AGENDA
HAYDEN PLANNING COMMISSION
THURSDAY, JANUARY 12, 2023
7:00 P.M.
HAYDEN TOWN HALL – 178 WEST JEFFERSON AVENUE, HAYDEN

AGENDA ITEM TITLE: Public Hearing: Staponski Project
Site Plan – New warehouse structure
431 Capital Street, Hayden

Re: Lot 31 Valley View Business Park
Four Points Project #2200-001

SITE PLAN

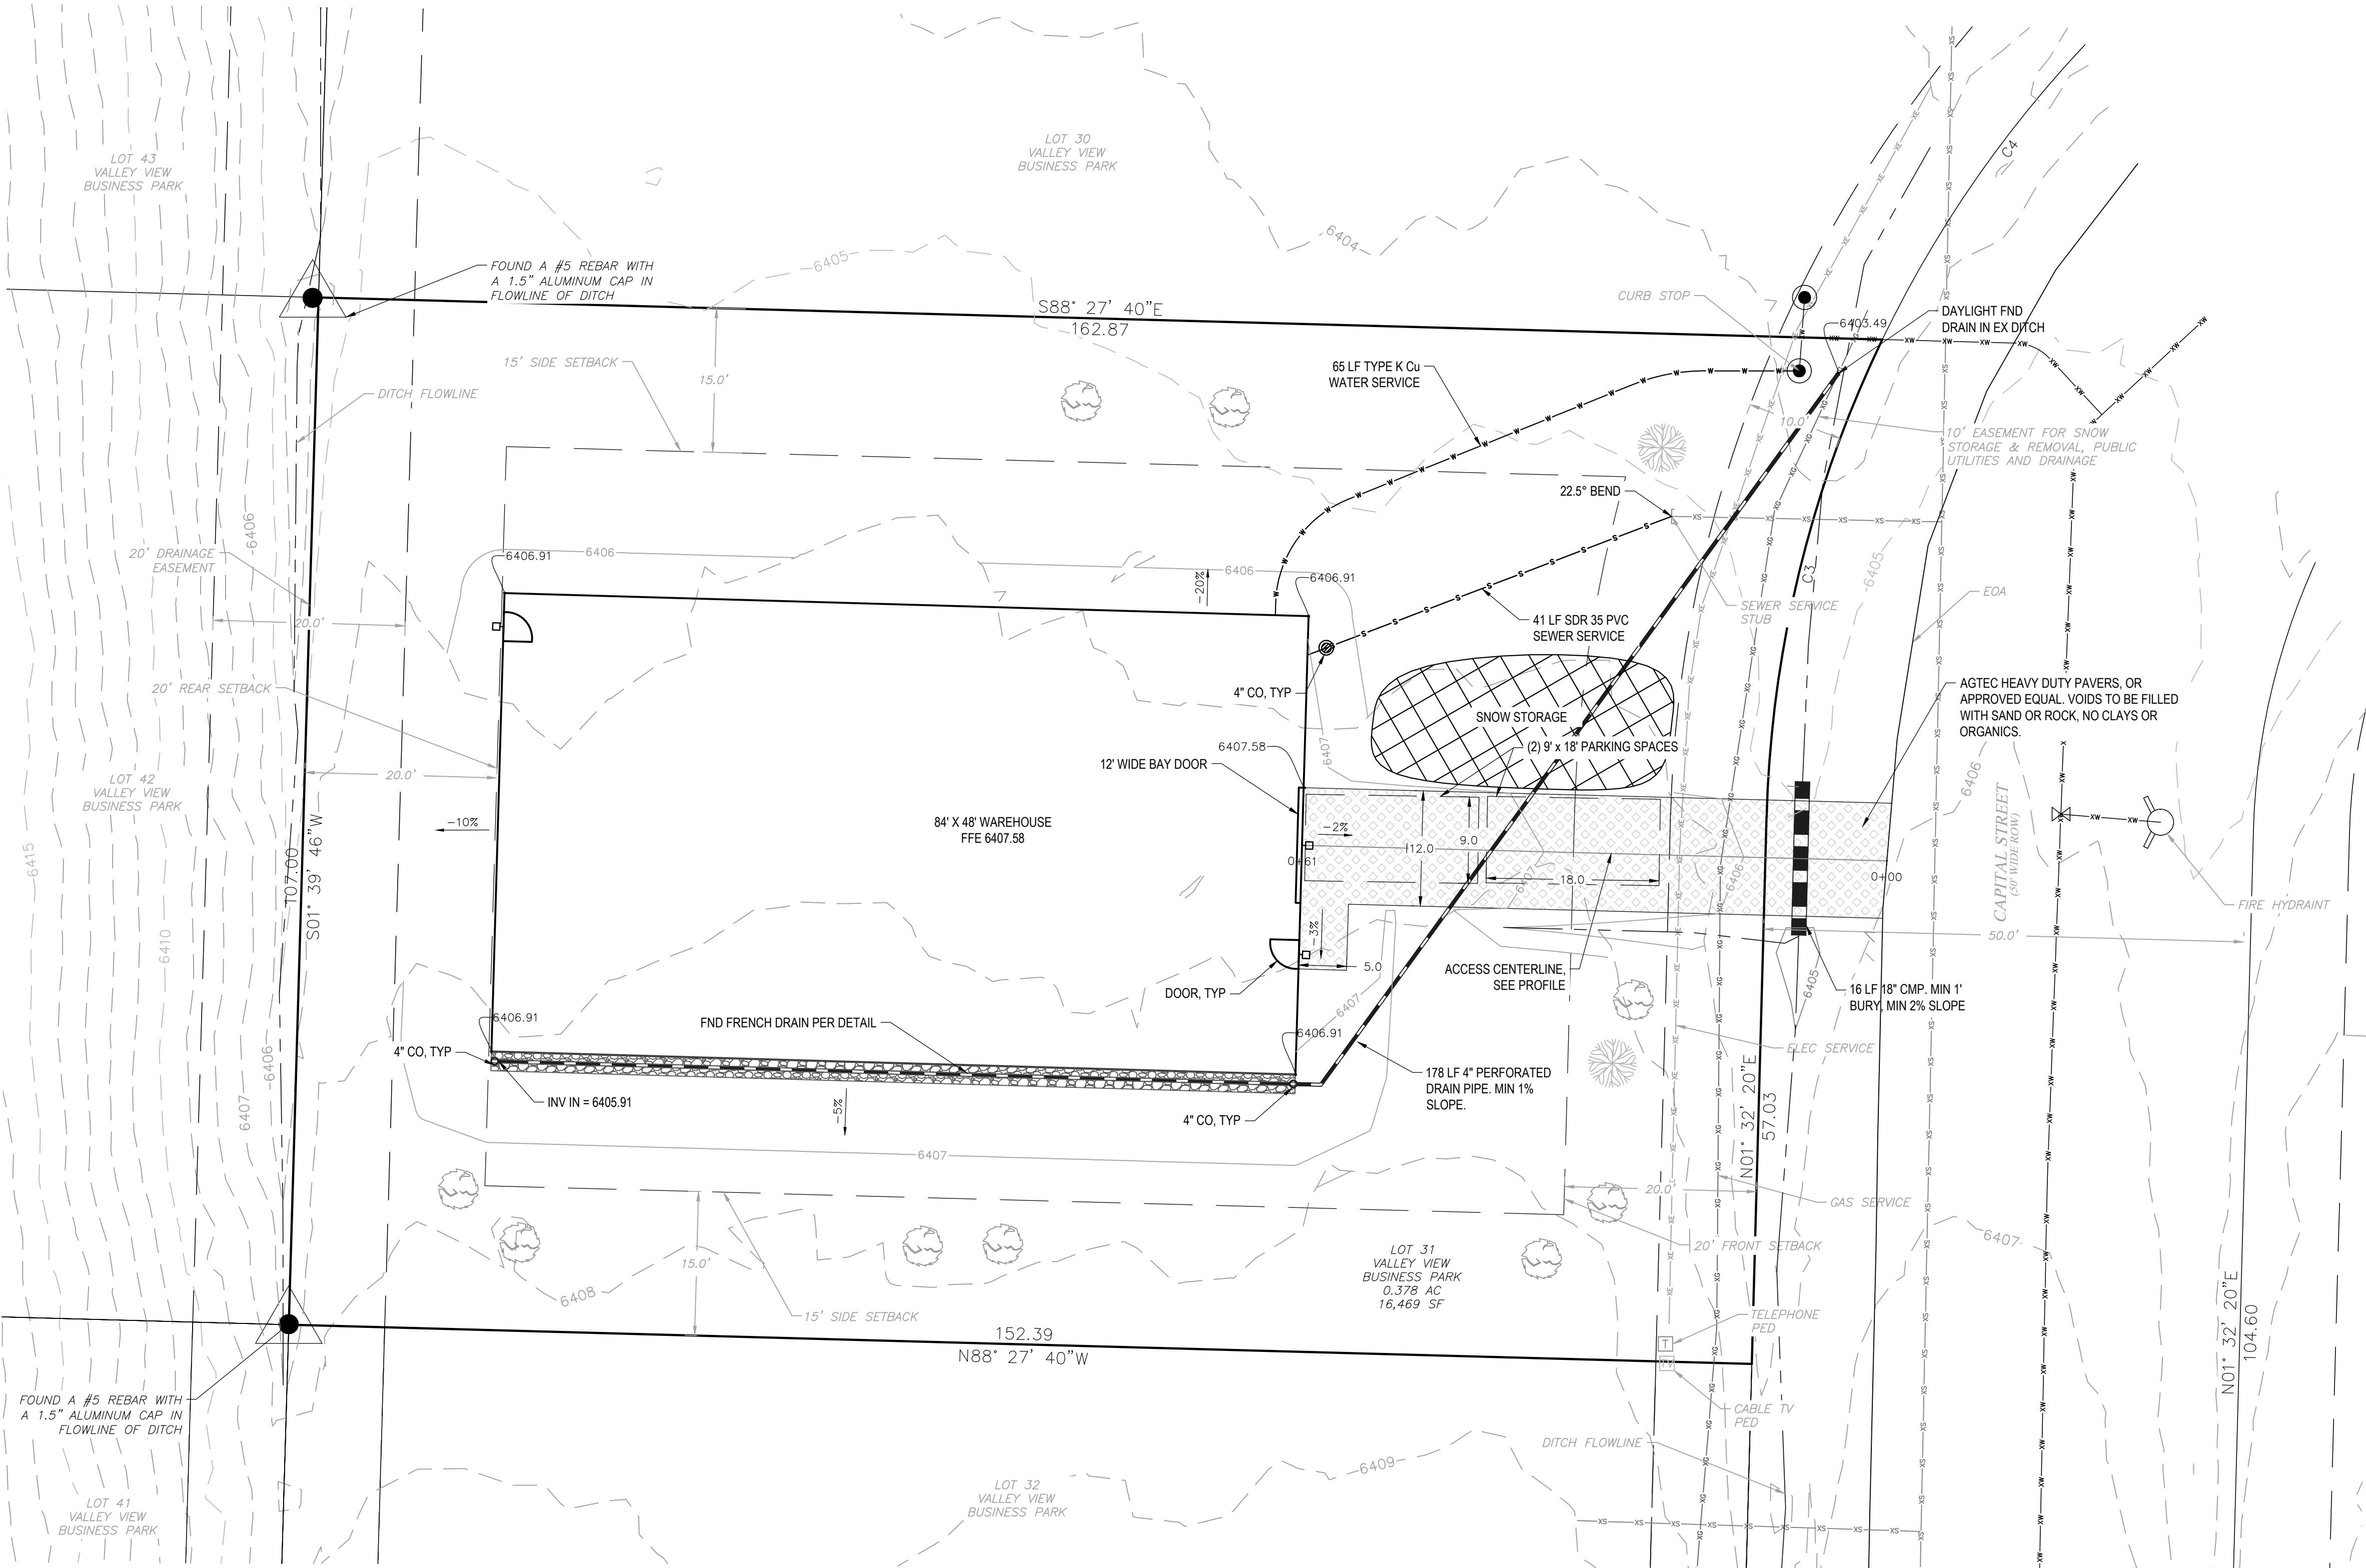
Complies		Section	Standards
Yes	No		
√	_____	-	Dimensional Standards Table 7.24-1. I-1 – Light Industrial Zone District. Minimum structure setbacks: 20’ from front property line, 15’ from side property line, and 20’ from rear property line. Maximum structure height: 35’. <i>Staff comment: The applicant’s site plan and elevations indicate that all setbacks and height standards are met.</i>

Complies		Section	Standards
Yes	No		
√	_____	B.	Industrial lot access to adjacent street. Driveway access to a local or collector street from a multi-family residential, commercial, business or industrial lot shall be greater than one hundred twenty-five (125) feet from any street intersection as measured from the intersecting right-of-way lines. <i>Staff comment: The proposed access point to the parcel exceeds 125’ from the nearest intersection.</i>

- √ _____
1. **Surface.** All parking and driveway areas and primary access to parking facilities shall be surfaced with asphalt, concrete or similar materials. *Staff comment: The applicant proposed the usage of an alternative driveway material. AGTEC Heavy Duty Pavers are a grid paver with voids that are filled with sand or rocks (depicted on sheet C1). Public Works reviewed the proposed material and commented that they feel is an appropriate material for this proposal.*

- √ _____
6. **Off-Street Parking Design.** Any off-street parking area shall be designed so that vehicles may exit without backing onto a public street unless no other practical alternative is available. Off-street parking areas shall be designed so that parked vehicles do not encroach upon or extend onto public rights-of-way, sidewalks or strike against or damage any wall, vegetation, utility or other structure. *Staff comment: As designed on the site plan, vehicles would access the public street by backing out of the property. A condition of approval has been included to require the installation of a turn-around feature to prevent backing onto the public street.*

- √ _____
8. **Striping.** All parking areas shall be striped to identify individual parking spaces. *Staff comment: Striping is not shown on the site plan. A condition is recommended below that requires the parking area be striped in accordance with this standard.*

vehicles used in connection with the facility **Staff comment:** *The applicant has indicated that there will not be any employees or clients visiting the property. Two parking spaces are proposed in the driveway and parking on the interior of the structure is permissible. A condition of approval has been recommended addressing possible future change of use to the structure and a required administrative re-evaluation of the parking plan.*

(4) *Number of handicap parking spaces: Total parking spaces in lot: 1-25: 1 space required. Staff Comment: One (1) accessible parking space must be provided in proximity to the entrances to the building. A recommended condition of approval has been included to address this requirement.*

1. The effective date of this approval is the date upon which the Planning Commission approves the application. The approval shall expire two (2) years from its effective date, unless a building permit has been issued or an application for renewal of the Site Plan approval is approved pursuant to Section 7.16.020, Hayden Development Code (HDC).
2. One (1) ADA accessible parking space shall be provided in proximity to the front entrances of the building pursuant to 7.24.100(e)(4).
3. A vehicle turn-around solution must be submitted to staff prior to issuance of a building permit that complies with Section 7.24.100(b)(6) to allow vehicles to exit the property without backing onto the public street.
4. Parking spaces must be striped pursuant to Section 7.24.100(b)(8).
5. Change of use of the Property will require an administrative review of the parking plans to verify requirements are met.

LANDSCAPE PLAN

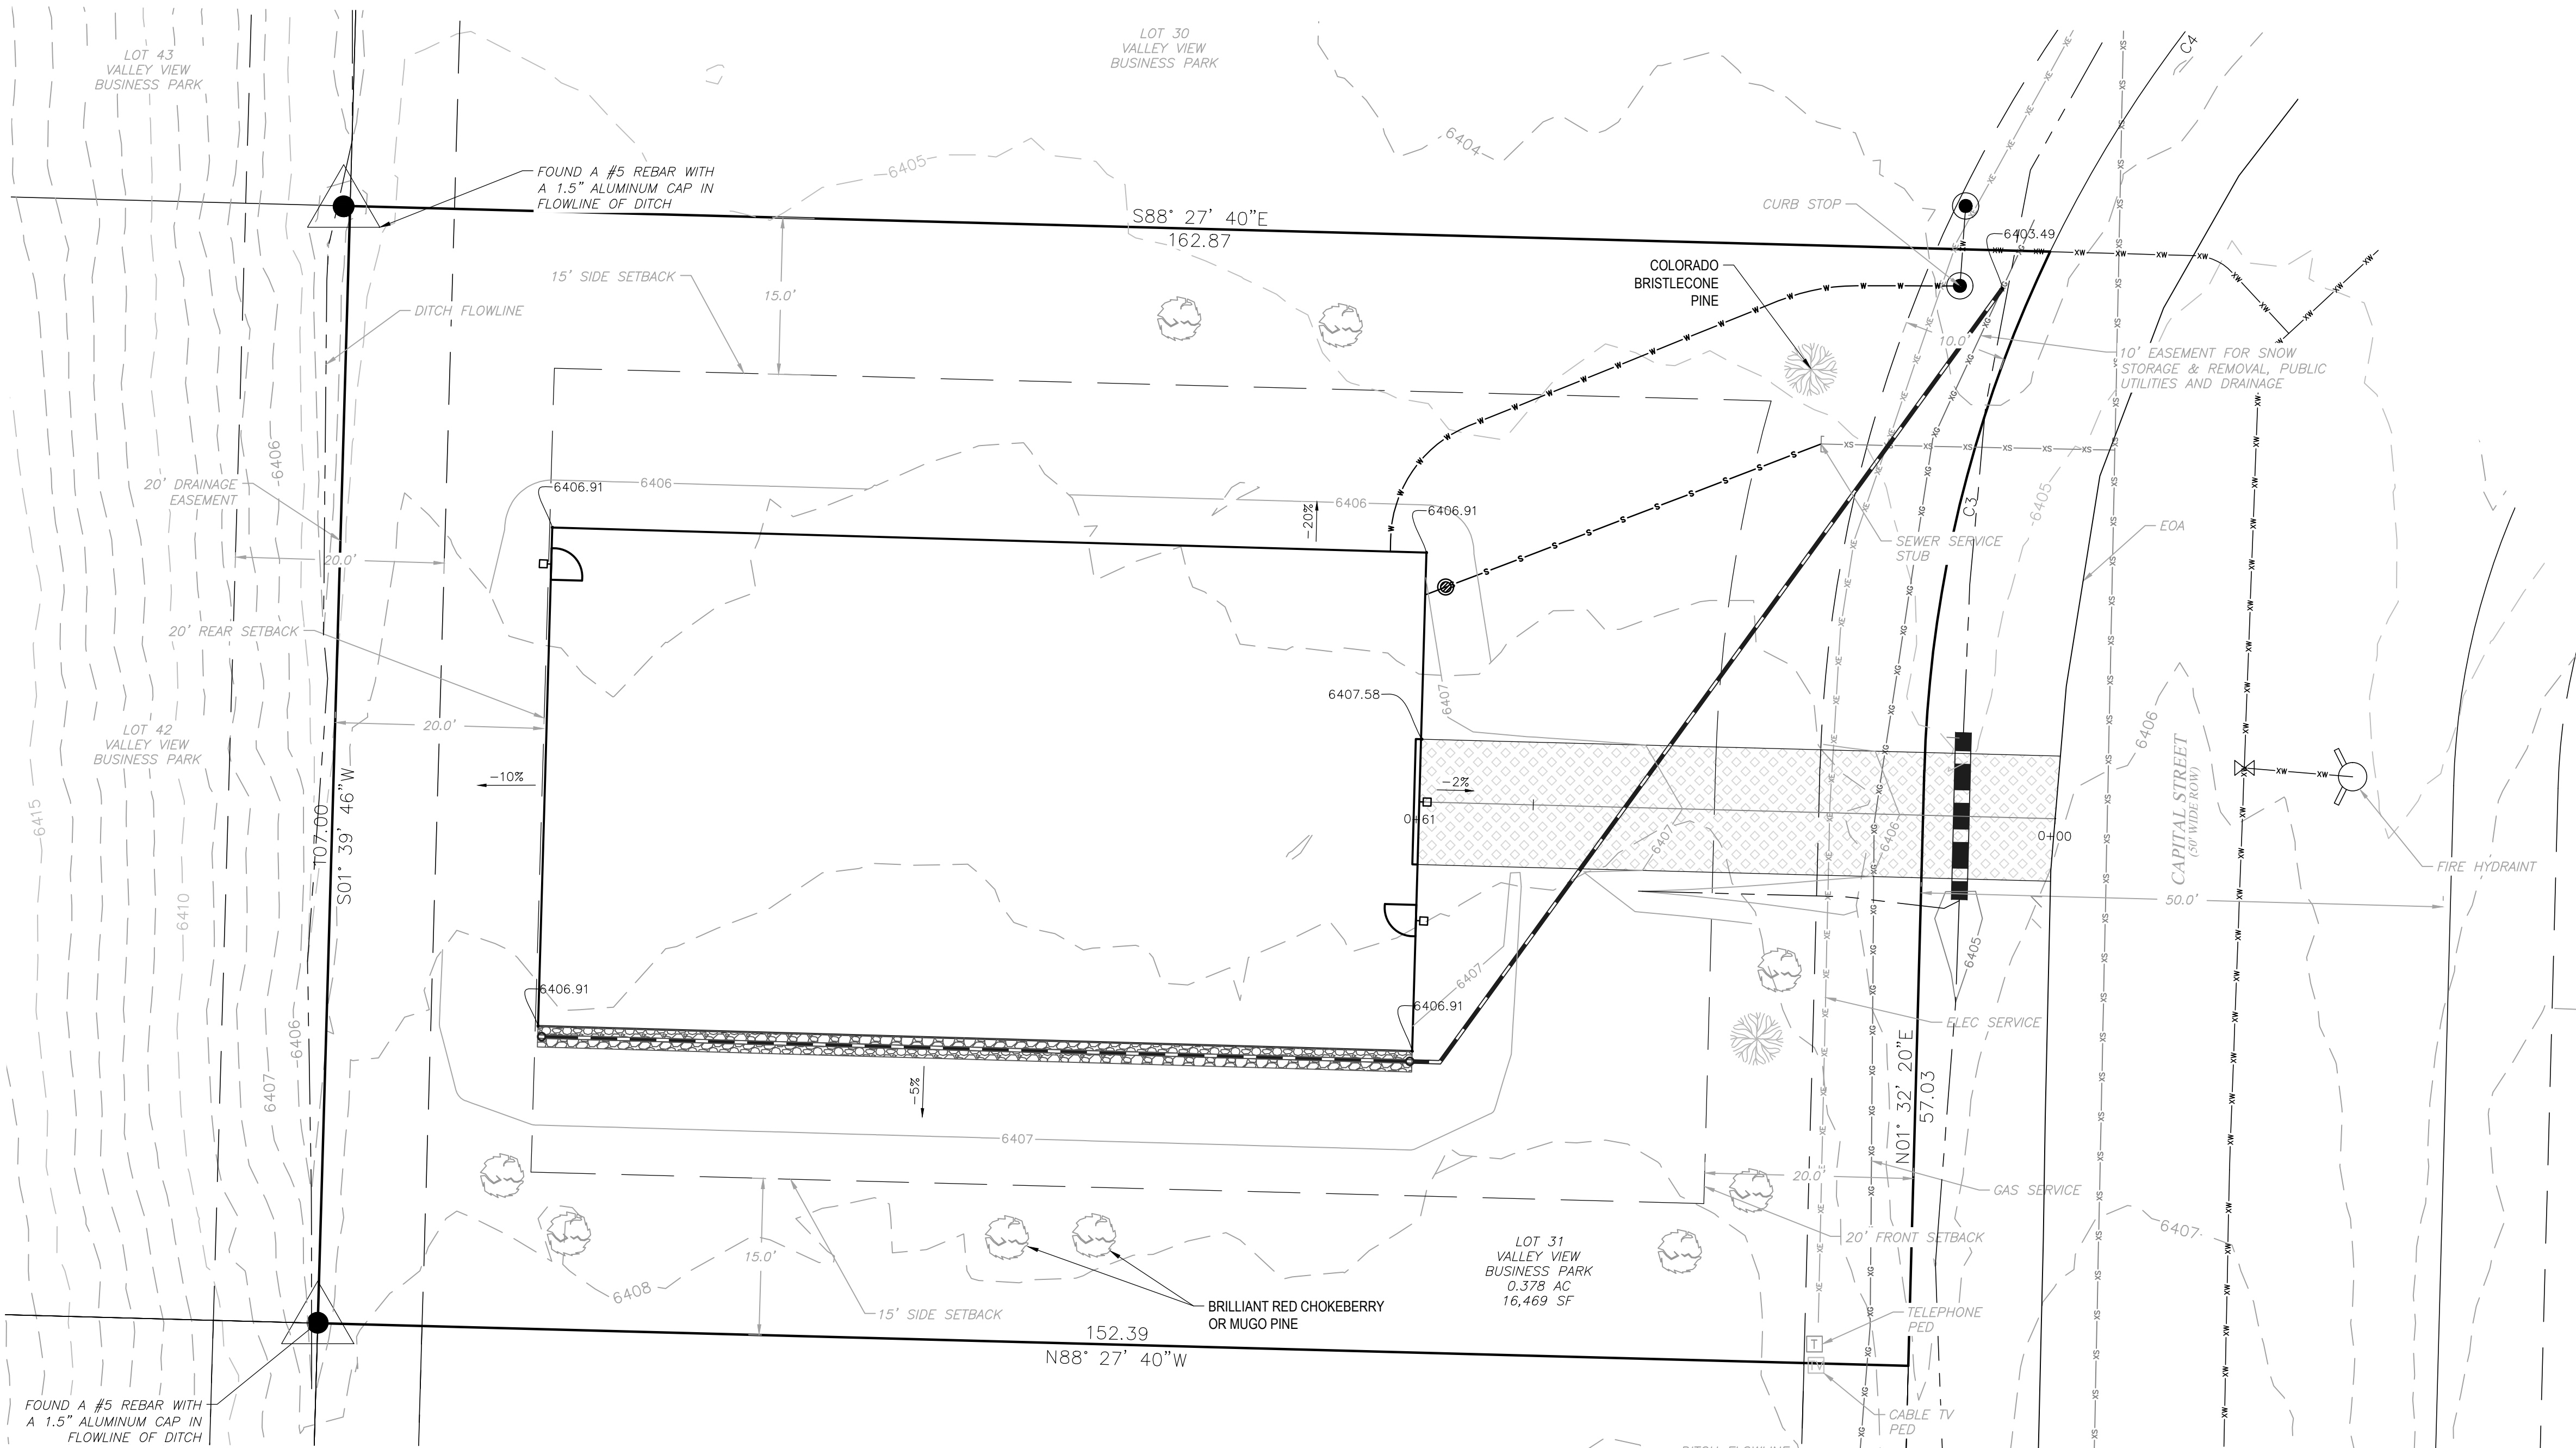
Complies		Section	Standards
Yes	No		
<input checked="" type="checkbox"/>	<input type="checkbox"/>	(3)	Industrial Development Landscaping Standards. Landscape improvements within the I-1 and I-2 districts shall be designed to enhance the overall appearance of the development and to integrate the project with adjacent land uses and into the surrounding neighborhood. A minimum of fifteen (15) percent of the site (gross) shall be landscaped area. Staff Comment: <i>The submitted landscaping plan indicates this standard will be met. The landscape plan shows 15% of the site will be landscaped.</i>
<input checked="" type="checkbox"/>	<input type="checkbox"/>	(i)	Required trees/shrubs The developer or assigns shall provide: (A) Site trees – plant a minimum of one (1) tree per one thousand five hundred (1,500) square feet of landscaped area, distributed on the site. (B) Shrubs – plant a minimum of one (1) shrub per three hundred (300) square feet of landscaped area. Group shrubs and distribute throughout the site. Trees may be substituted at the discretion of the Planning Commission at site plan review. Staff comment: <i>Required landscape area is 2,470 sq. ft. and the landscape plan indicate two (2) trees, 9 (nine) shrubs, and native grass seeding are noted.</i>
